### 233124 PSC Modifications **Imperial Oil Resources Limited**

Subject: NPS 24X26 Froth Spool Reducer

#### SP-K3492

### Response to RFI 1397868-B91-003

Figure 1: 074-2300-080-141-009 01 Rev 0

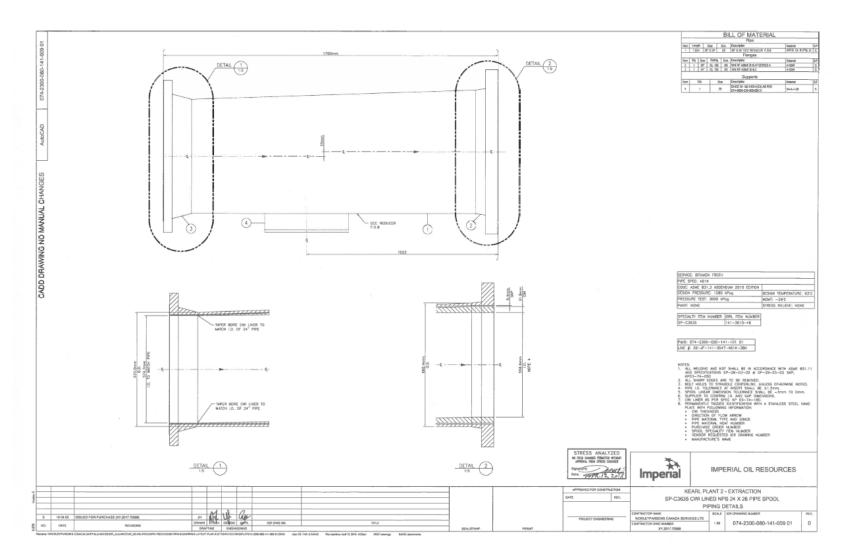
Drawing 074-2300-080-141-009 01 rev 0, (*Figure 1*), shows liner tapering down to 0 thickness. Supplier cannot achieve this taper depicted.

The Proposed solution as shown in Figure 2 (Section B-B shown in comparison sketch) is acceptable.

Figure 2: A1-18001 Spool SP-C3635 comparison sketch

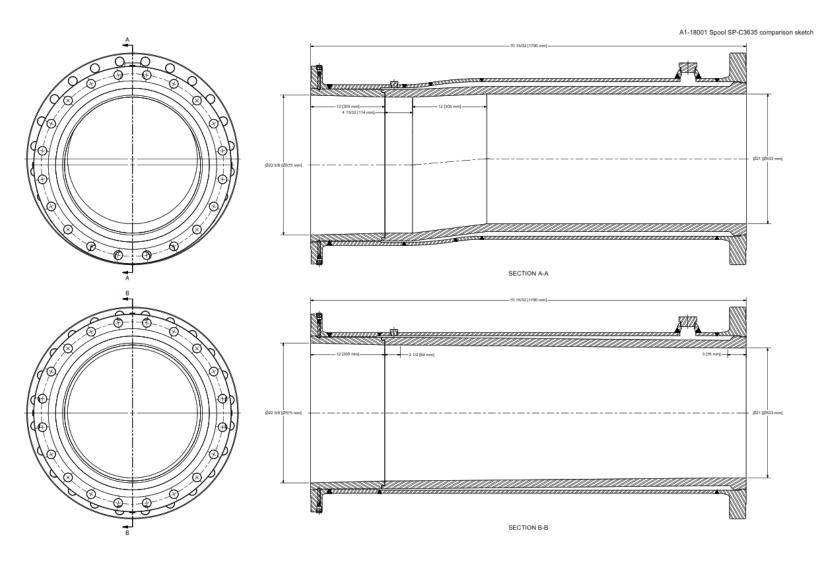
Supplier instead proposes another option:

See A1-18001 Spool SP-C3635 comparison sketch (*Figure 2*) spool depicted on the bottom of the drawing boxed in red (section B-B). One end has a 24" flange and the other ad 26" flange, while the pipe between the flanges is 26". The liner ID reduces from 22 5/8" to 21" as shown on the sketch, in order to match the ID on the inlet of the froth elbow spool it connects to. Please note that the centerline of this proposed option is not offset as shown on 074-2300-080-141-009 01 rev 0. Supplier requests if this option described above is acceptable.

- 1) Eccentric reducer spool is changed to straight spool reducer with 22 5/8" x 21" liner ID as per Attachment 4. One end of spool will have 24" CL 150 custom flange and other end as 26" CL 150 Flange.
- 2) TOS for the shoe needs to be lowered to account for the change from eccentric reducer to Modified 26 x 24 straight reducer as per Attachment 1.
